ATR on Quality Control Check Repot. (Apartments)

Flat No	A-104	QC report stage	After finishing stage	Sl. No.	37829
Company	MPL	Project	MFP	Phase	-
Prepared by	Sravani-K	Sign	[Signature]	Date	28/6/21
Project Manager	Subbarathy S.V	Sign	[Signature]	Date	28/6/21
Receipt by QC date	26/6/21	Sign		Other	-
Receipt at HO date		Sign		Other	-
Checked By MD on		MD Sign		For filling	☐ Yes ☐ No

MAYFLOWER PLATINUM

Details of Additions & Alterations

Description	Direction	Owners & Developers :	Date :	Promoted by
WORKING DRAWING OF FLAT.NO. A-4	N	Modi Properties Pvt Ltd.	18.03.2020	Modi Properties Pvt. Ltd
		Project Name & Phase :	Prepared By :	Phone: +91-40-66335551
		MAYFLOWR PLATINUM	Approved By : Soham Modi	
			\$: N.T.S

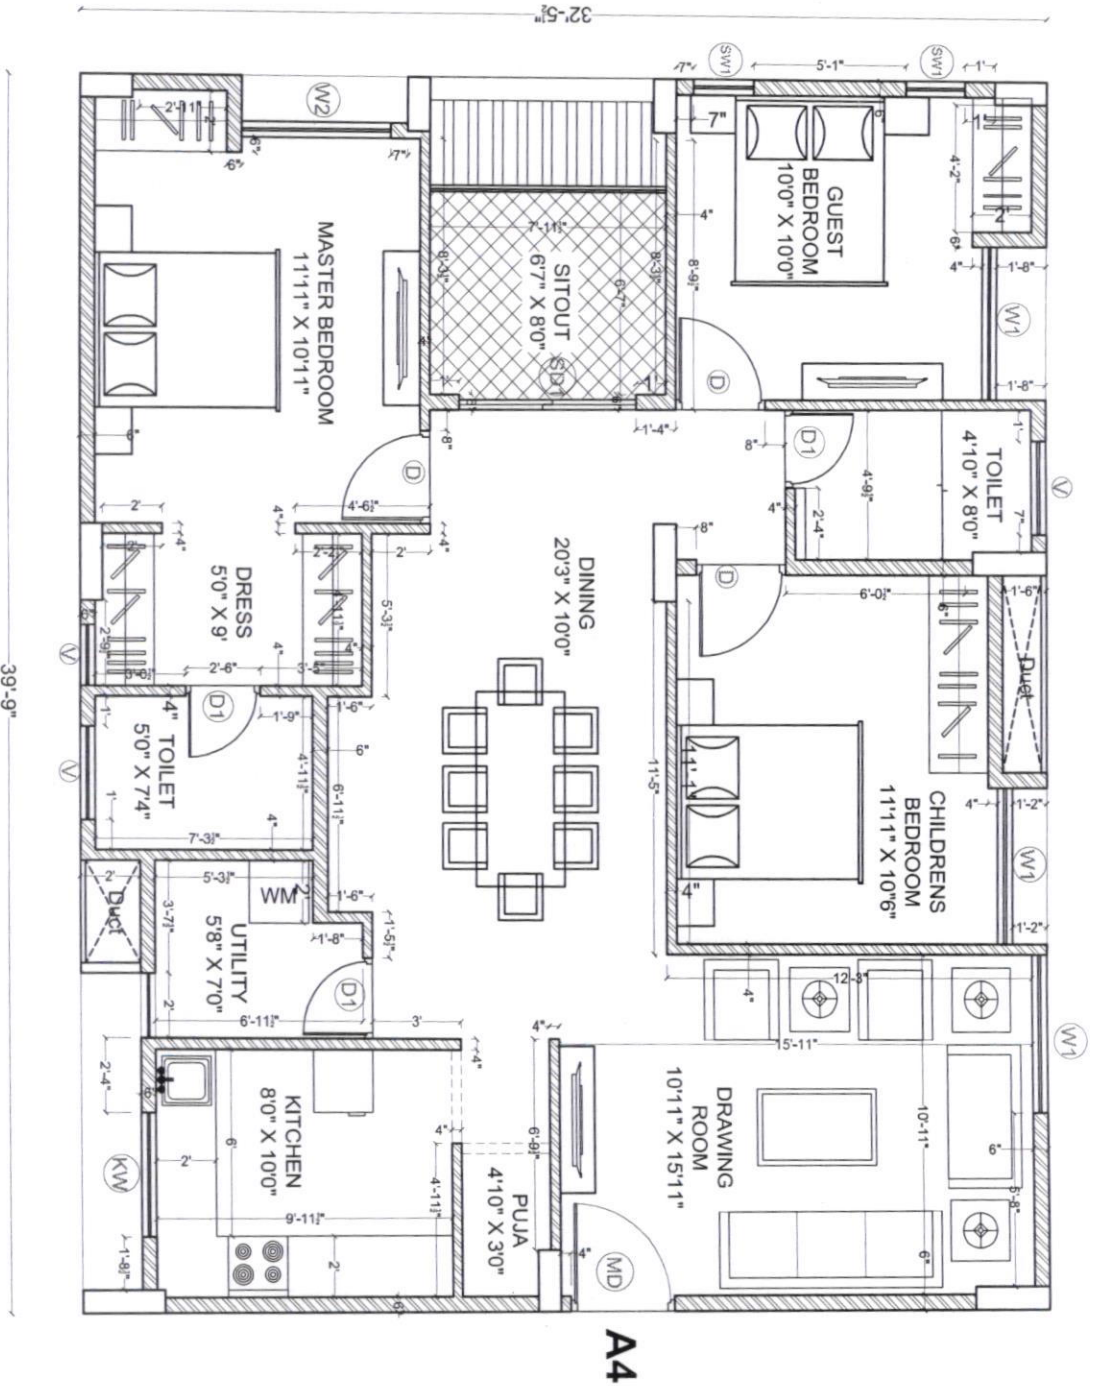
Changes in kitchen platform: (mark on plan)

Sink should be shifted to
Pooja wall.
Kitchen platform ht 31".

Other Changes:

Nil
① All window 3 doors.

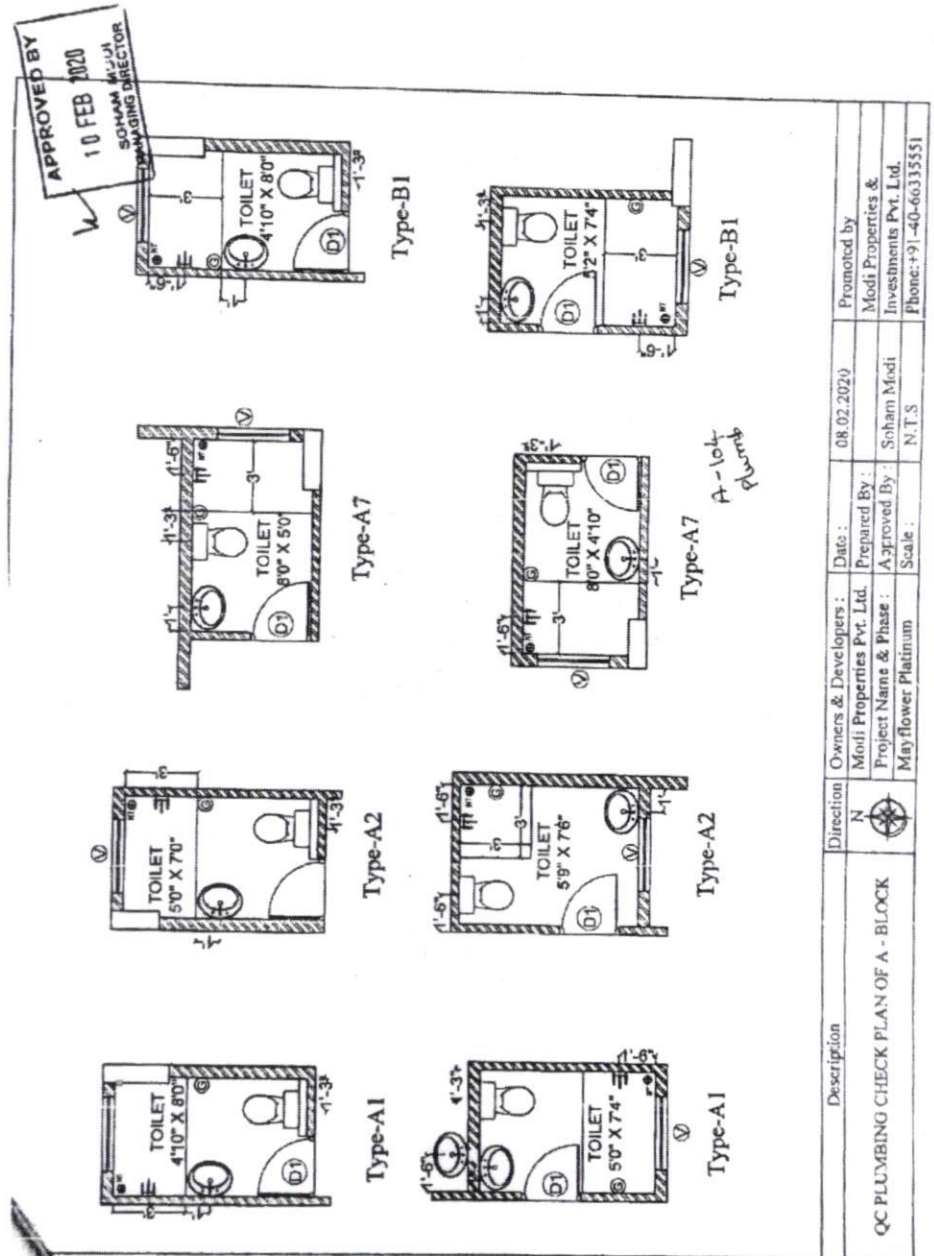
S No	Room	Civil work near pipes in balcony & utility (✓ or ✗)	CPVC & PVC Check (✓ or ✗)	Electrical points check (✓ or ✗)	Water proofing check (✓ or ✗)	Proper use of fasteners check (✓ or ✗)	Placement of DB (✓ or ✗)	Placement of Generator changeover (✓ or ✗)
1	Bedroom 1 M.B	✓	✓	✓	✓	✓	✓	✓
2	Toilet 1 M.B	✗	✗	✓	✓	✓	✓	✓
3	Bedroom 2 M.B	✓	✓	✓	✓	✓	✓	✓
4	Toilet 2 C-Toi	✗	✗	✓	✓	✓	✓	✓
5	Bedroom 3 M.B	✓	✓	✓	✓	✓	✓	✓
6	Toilet 3 M.B	✓	✓	✓	✓	✓	✓	✓
7	Drawing	✓	✓	✓	✓	✓	✓	✓
8	Dining	✓	✓	✓	✓	✓	✓	✓
9	Lobby-1	✓	✓	✓	✓	✓	✓	✓
10	Utility balcony 1	✓	✓	✓	✓	✓	✓	✓
11	Utility balcony 2	✗	✗	✓	✓	✓	✓	✓
12	Utility balcony 3	✓	✓	✓	✓	✓	✓	✓
13	Kitchen	✓	✓	✓	✓	✓	✓	✓
14	Other	✓	✓	✓	✓	✓	✓	✓
15	Other	✓	✓	✓	✓	✓	✓	✓
Remarks No TE AT Toilets & wash areas, PVC outlet pipes & flush tanks not provided. 4" thick ledge wall and concrete cutting works are pending at Toilets. 1st Coat Luffam paint not provided inside the flat. Remarks on additions & alteration sheet: Till now no addition & alteration had taken from customer.

Description	Direction	Owners & Developers :	Date :	Promoted by
QC PLUMBING CHECK PLAN OF A - BLOCK	N	Modi Properties Pvt. Ltd.	08.02.2020	Modi Properties &
		Project Name & Phase :		Investments Pvt. Ltd.
		Approved By :	Soham Modi	Phone: +91-40-66335551
		Scale :	N.T.S

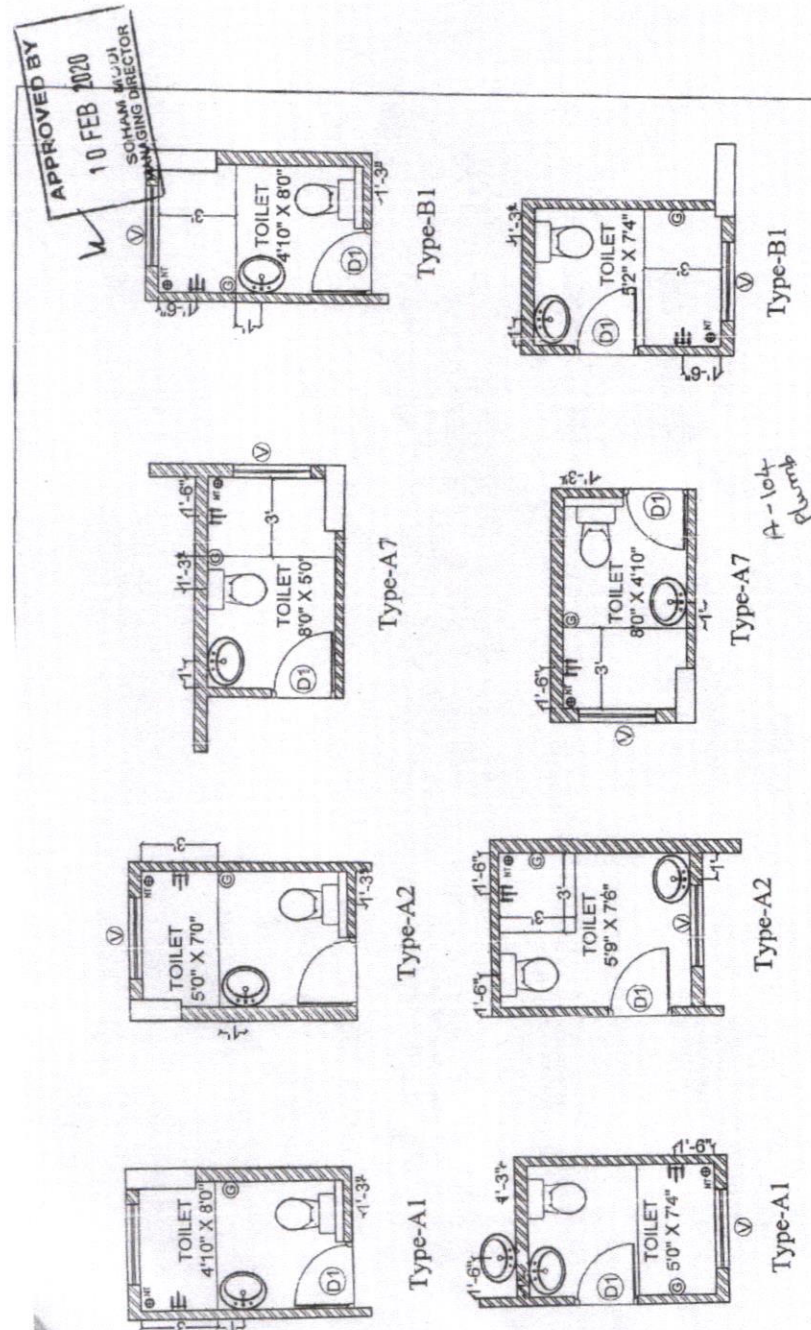
S No	Room	Civil work near pipes in balcony & utility (✓ or ✗)	CPVC & PVC Check (✓ or ✗)	Electrical points check (✓ or ✗)	Water proofing check (✓ or ✗)	Proper use of fasteners check (✓ or ✗)	Placement of DB (✓ or ✗)	Placement of Generator changeover (✓ or ✗)	
1	Bedroom 1 M.B	-	-	✓	-	-	-	-	
2	Toilet 1 M-Toi	X	X	✓	✓	-	-	-	
3	Bedroom 2 M.B	-	-	✓	-	-	-	-	
4	Toilet 2 C-Toi	X	X	✓	✓	-	-	-	
5	Bedroom 3 M.B	-	-	✓	-	-	-	-	
6	Toilet 3 M-Toi	-	-	✓	-	-	-	-	
7	Drawing	-	-	-	-	-	-	-	
8	Dining	-	-	✓	-	-	✓	✓	
9	Lobby-4	-	-	✓	-	-	-	-	
10	Utility / balcony 1	-	-	-	-	-	-	-	
11	Utility / balcony 2	-	X	✓	-	-	-	-	
12	Utility / balcony 3	X	X	✓	✓	-	-	-	
13	Kitchen	-	-	-	-	-	-	-	
14	Other	X	X	✓	-	-	-	-	
15	Other	-	-	-	-	-	-	-	
Remarks									
NOTE: 1. At Toilets & wash areas, PVC outlet pipes & flush tanks not provided. 2. 1/4" thick ledge wall and concrete cutting works are pending at Toilets. 3. 1st Coat of Plaster paint not provided inside the flat. Remarks on additions & alteration sheet: Till now no additions & alterations had taken from customer.

- 1) outlet pipe connection provided
- 2) Flush concealed tank not received due to lockdown
- 3) one coat of lappam will be done in stage-I
